## Process Sheet

Customer : CU-DAR001 Dart Helicopters Services	Drawing Name : 350 SKIDTUBE ASSEMBLY RH
Job Number : 32642	
Estimate Number : 10265	
P.O. Number :	Part Number : D350636012
This Issue : 5/25/2007 S.O. No. :	Drawing Number : D2750 <u>UNDER REVIEW</u> CB
Prsht Rev. : NC	Project Number : N/A
First Issue : / / Type : LANDING GEAR	Drawing Revision : D
Previous Run : 32641	Material :
Written By : <u>07.05.28</u>	Due Date : 6/30/2007 Qty: 1 Um: Each
Checked & Approved By : <u>07.05.28</u>	
Comment : Est Rev: I 02.09.25 Rearranged procedure steps KJ	
Est Rev: J 06-03-29 As per Rev D EC	
Est Rev: J 06-07.13 As per dsi9343 EC

**D2750-043/-044 ASSEMBLY**  
D2750-043 SHOWN (D2750-044 OPPOSITE)

350 SKIDTUBE ASSEMBLY

D2750-041/-042 ASSEMBLY  
D2750-041 SHOWN (D2750-042 OPPOSITE)

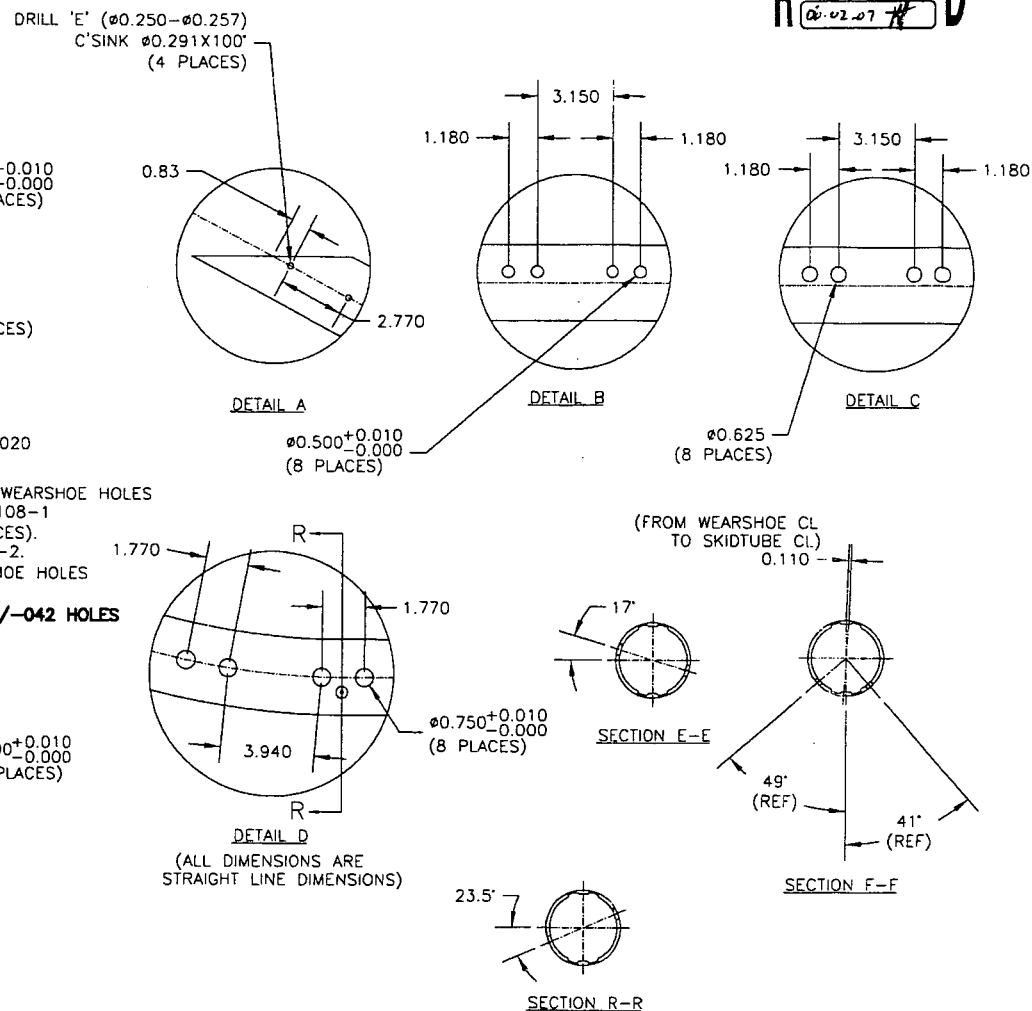
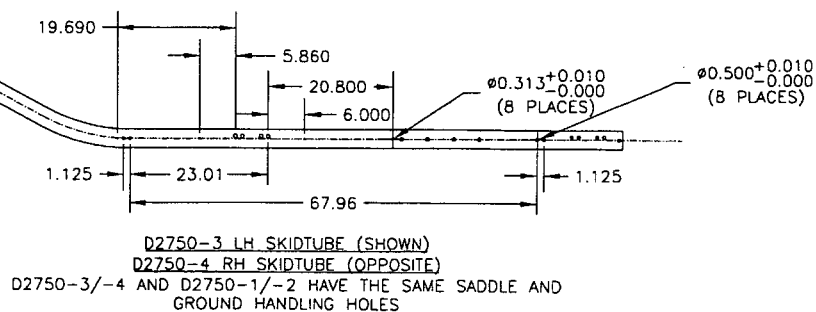
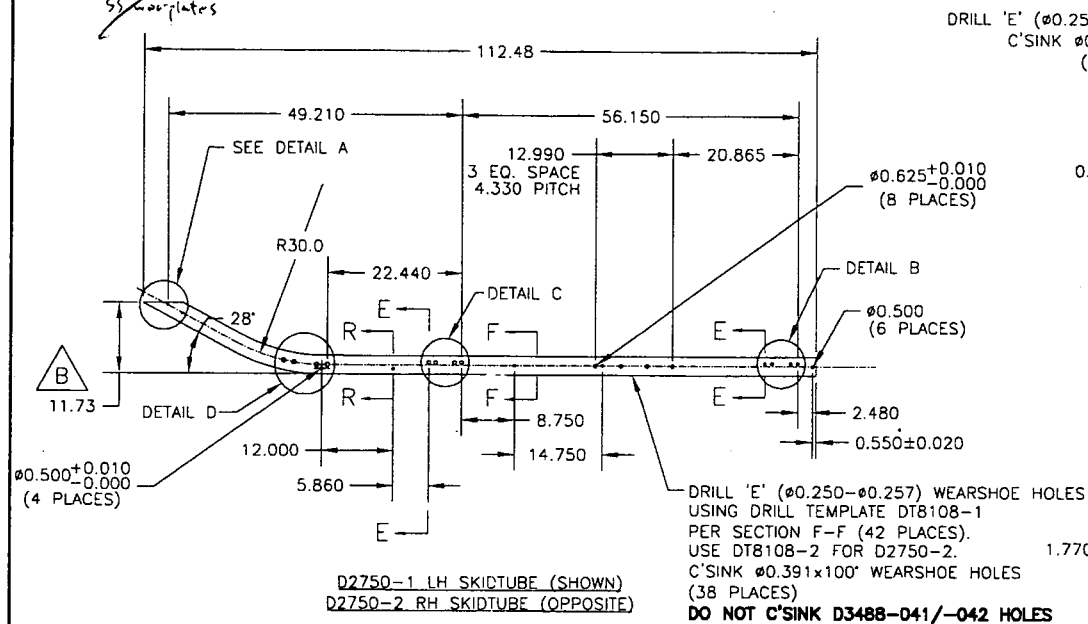
UNDER REVIEW

07.07.05 CB  
54 wear plates
